# Appendix C

Jeffery Schmitt, Chairman  
Members of Duanesburg Planning Board  
Town of Duanesburg  
5853 Western Turnpike  
Duanesburg, NY 12056

4 February 2022

Town of Duanesburg  
Planning Board Minutes  
December 16<sup>th</sup>, 2021  
**Draft Copy**

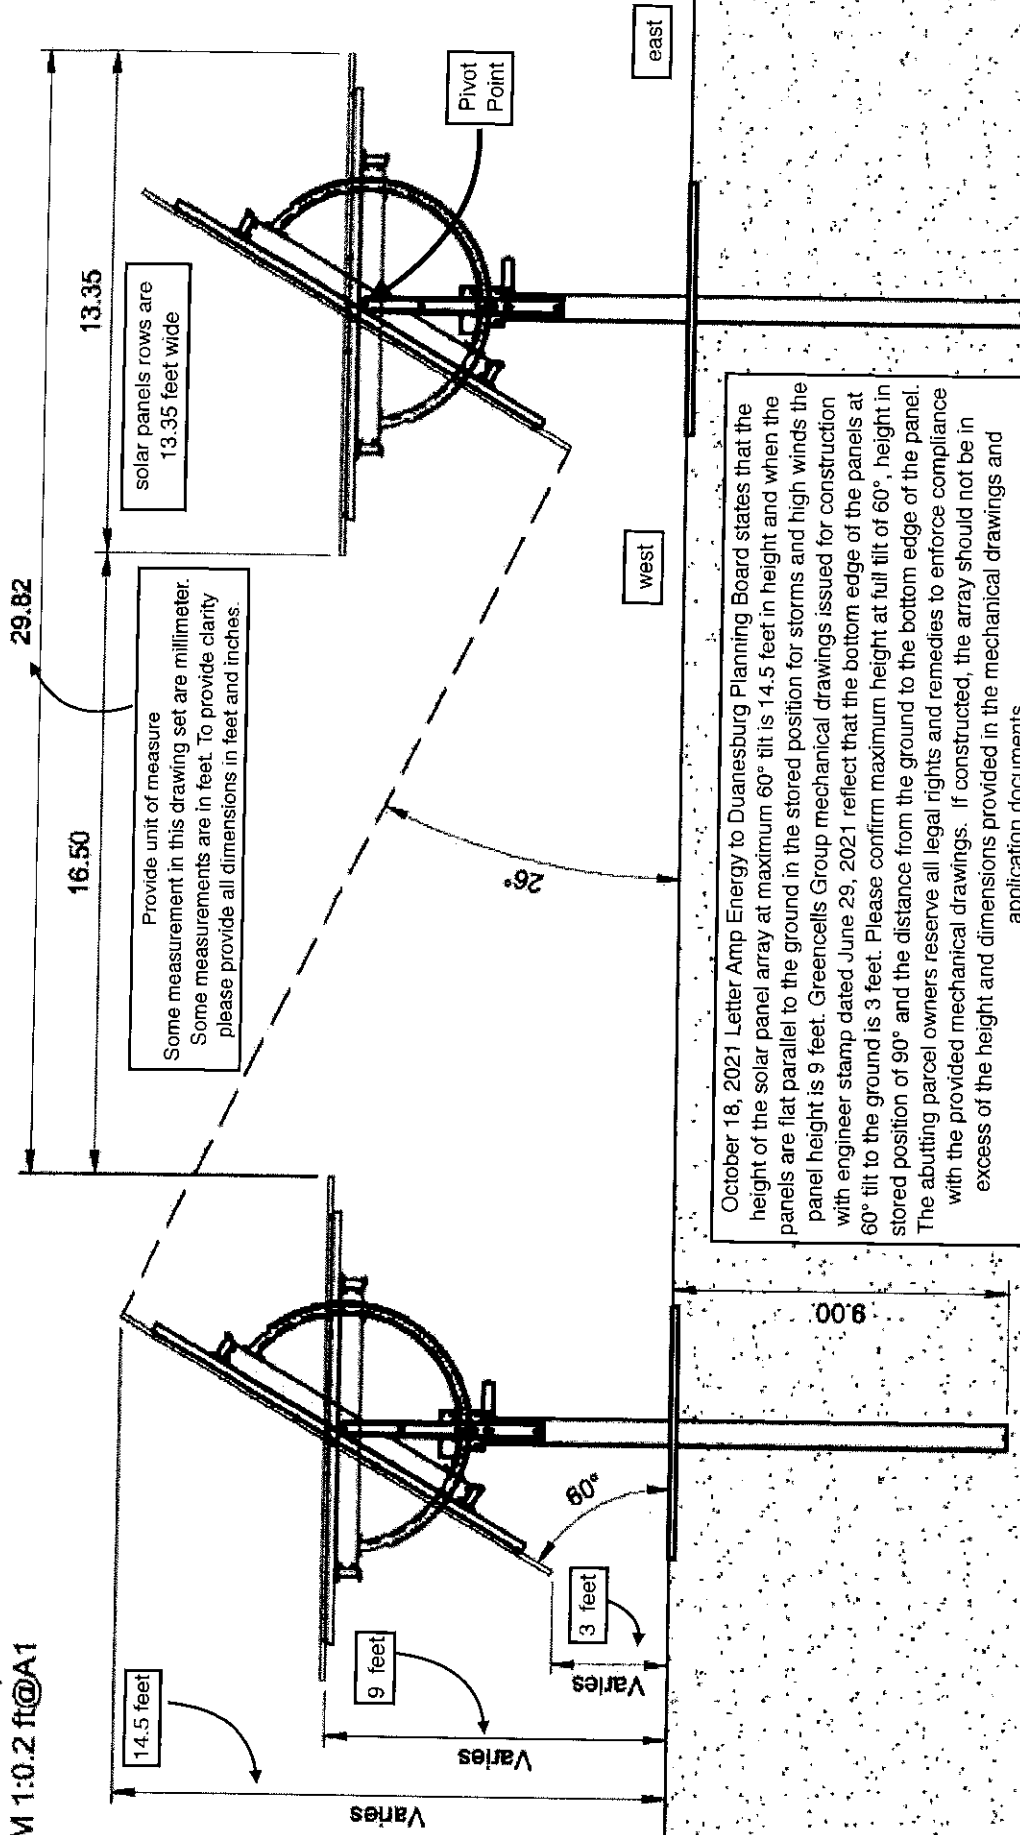
Solar Law 3.j. No discernable noise  
difference at the property line. Is the  
Project compliant with Solar Law 3.j.?

Zoning Ordinance 5.7.1 limits fence height to 6 feet.  
Has the Applicant obtained a zoning variance?

October 18, 2021 Letter Amp Energy to Duaneburg Planning Board states that the height of the solar panel array at maximum 60° tilt is 14.5 feet in height and when the panels are flat parallel to the ground in the stored position for storms and high winds the panel height is 9 feet. Greencells Group mechanical drawings issued for construction with engineer stamp dated June 29, 2021 reflect that the bottom edge of the panels at 60° tilt to the ground is 3 feet. Please confirm maximum height at full tilt of 60°, height in stored position of 90° and the distance from the ground to the bottom edge of the panel. The abutting parcel owners reserve all legal rights and remedies to enforce compliance with the provided mechanical drawings. If constructed, the array should not be in excess of the height and dimensions provided in the mechanical drawings and application documents.

Exhibit B 2019 Application for Special Use Permit

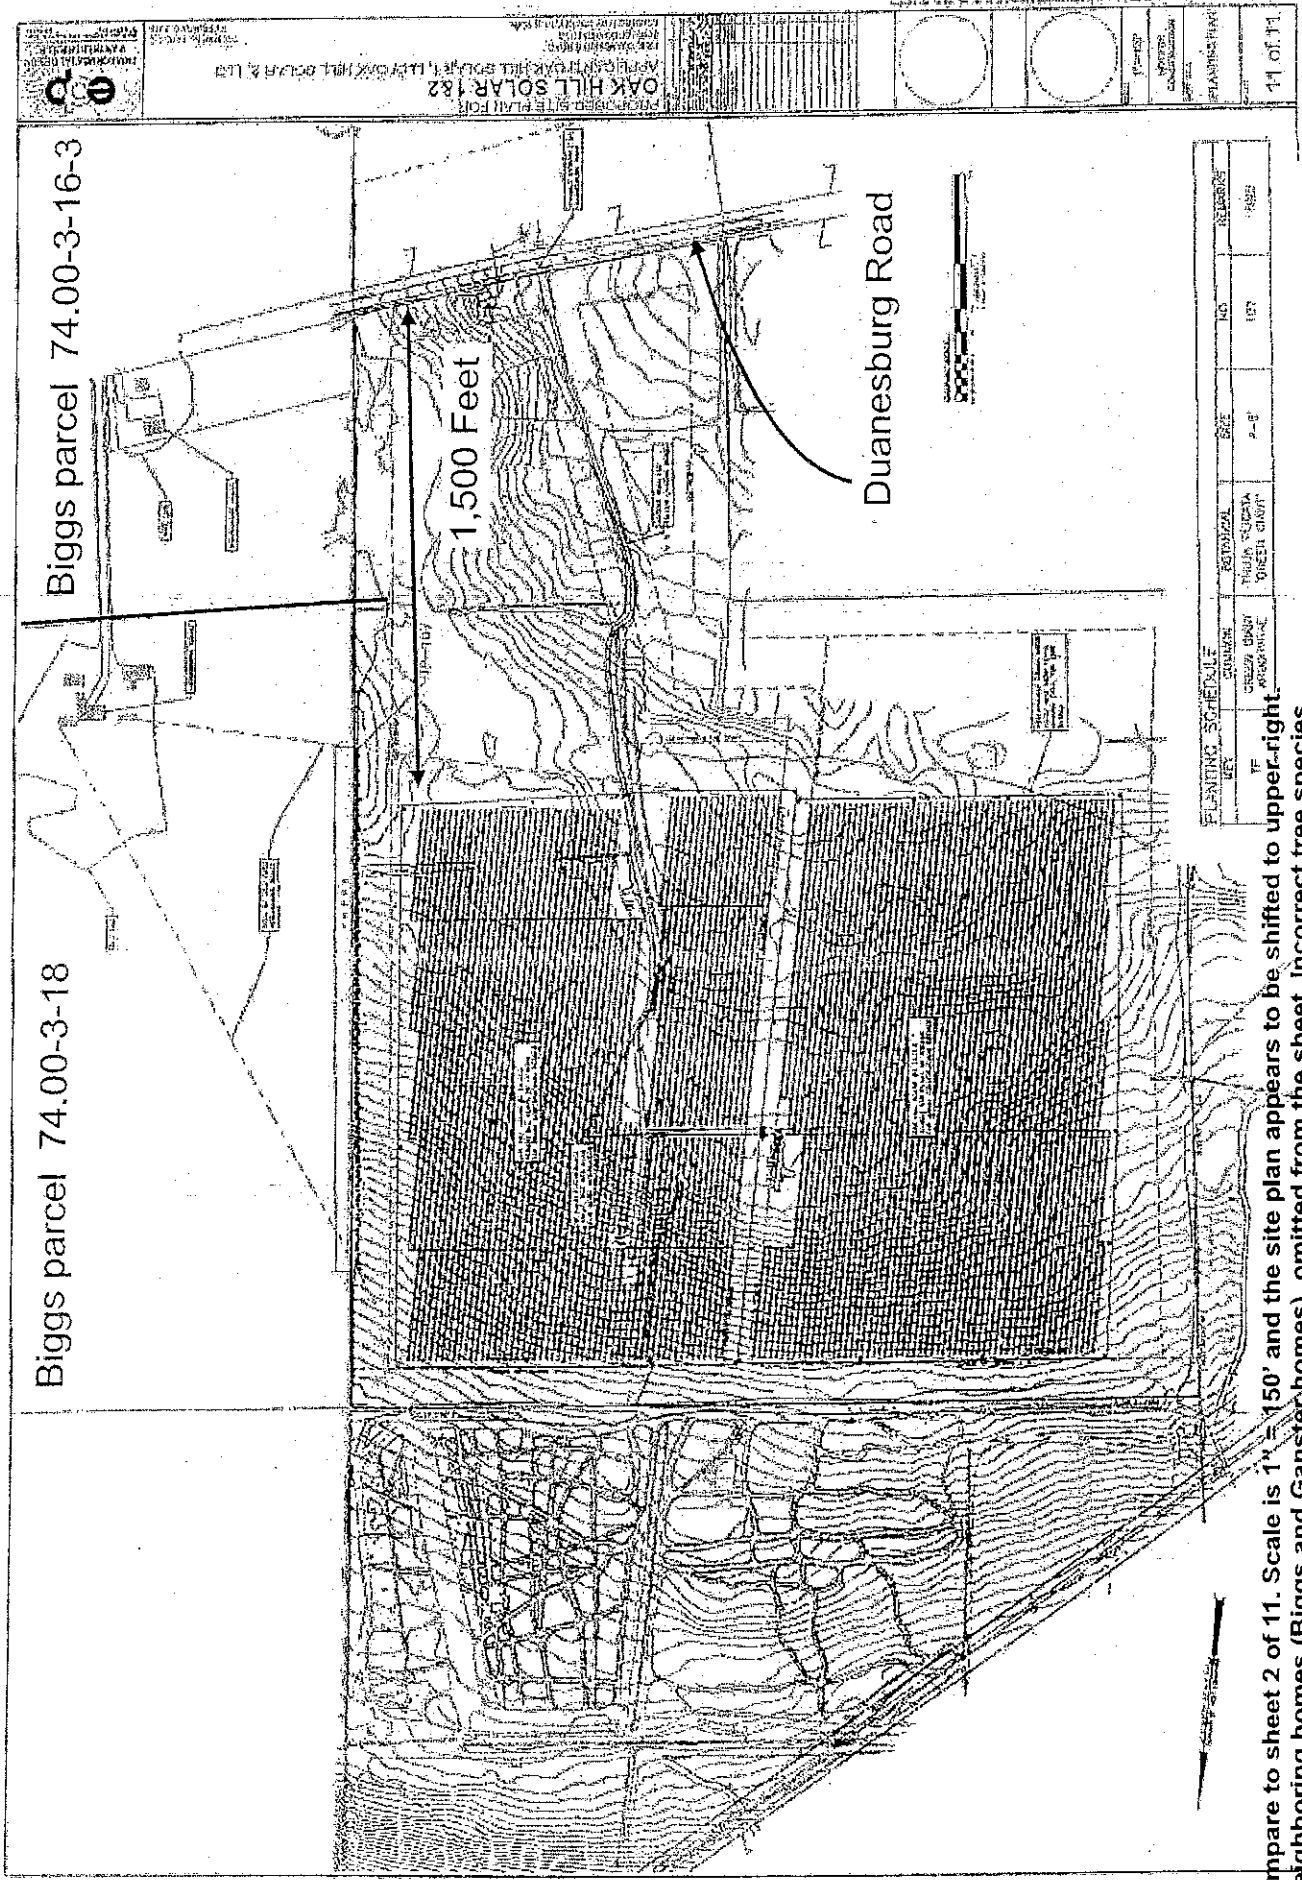
Compare to sheet 2 of 11. Scale is 1" = 150' and the site plan appears to be shifted to upper-right. Neighboring homes (Biggs and Ganster homes) omitted from the sheet. Incorrect tree species. Incorrect date - Planting Plan provided in August 2019.
